From: Jacobson, Richard -FS
Sent: Monday, September 21, 2020 10:46 AM
To: Dillman, Marla -FS; Sladek, Helen L -FS; Reynolds, Becki L -FS; Mahara, Carol J -FS; Jacobson, Richard -FS; Wolvin, Denise - FS; Donnelley, Shona - FS; Brigham, Delilah A -FS; Moszynski, Stanislaw K -FS; Shuler, Scot W -FS; Dillman, Karen -FS; Cancino Hernandez, Valeria - FS; Rizzo, Eric - FS; Simonson, Molly -FS; Baichtal, James F -FS; Maldonado, Lucy G -FS
Subject: FW: Conditional Use permits

Information regarding the potential reroute of the Thorne Bay access road. My suggestion would be to stay with the proposed original line and plan on decommissioning once logging is completed.

The dark line is my flagged alignment and the light line is the suggested USFS reroute. The imagery is a hill shade relief from the 2017 POW LiDAR imagery.

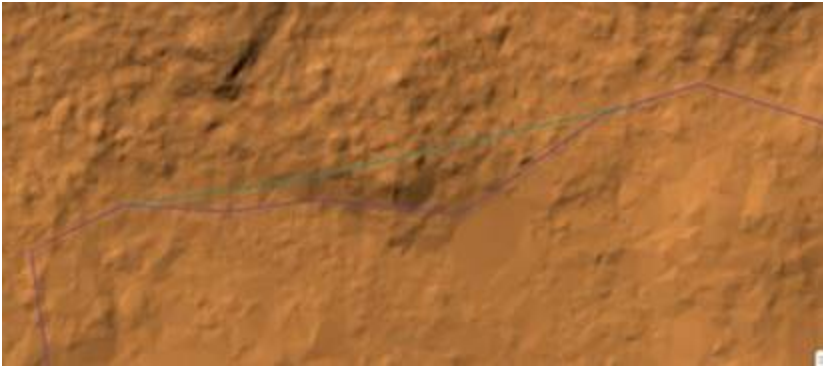
Regarding Richard's email below on 7/30, an alternate alignment to the access road into the proposed Thorne Bay Overlook timber sale was suggested. On 9/2 I had the opportunity to revisit the site with Will Johnson from the Thorne Bay SECON office. It was good to have another set of eyes on the area to assess the possibilities, but as someone who builds a lot of road, he agreed that the original flagged alignment made the most sense. Some deviation from the original alignment is possible but it would be very minimal, as cutting through the knob visible in the image below would be extremely costly. This is due to the through-cut depth, endhaul and the associated labor involved with that challenging road construction. Here's the concerns which arose when reevaluating the original flag line:

- We would need to find a location for the overburden waste generated from the through-cut, which could be as much as 15-feet at the high point. Sidecasting is not an option, as there is no suitable location for deposit.
- The ~\$250,000 estimated cost of the new alignment would negate the revenue earned from the timber harvest, therefore the project would not occur if the reroute were forced upon us.

While the 300-foot re-route in question is technically a forested wetland as stated in the email below, the road would be constructed on solid dry ground with adequate cross drainage of three culverts. 18" pipes would work but we'd be willing to go to 24" if needed. There are no fish concerns here and even following a very wet week, the amount of water was minimal. Thank you for considering the obstacles in rerouting the alignment.

One note on the Thorne bay site, it has been recommended that the alignment be altered slightly. See image below, switching to the red alignment would avoid a small section of forested wetlands that resource folks have concerns over. It would require a through cut but it is a feasible route. If you have concerns please let me know.
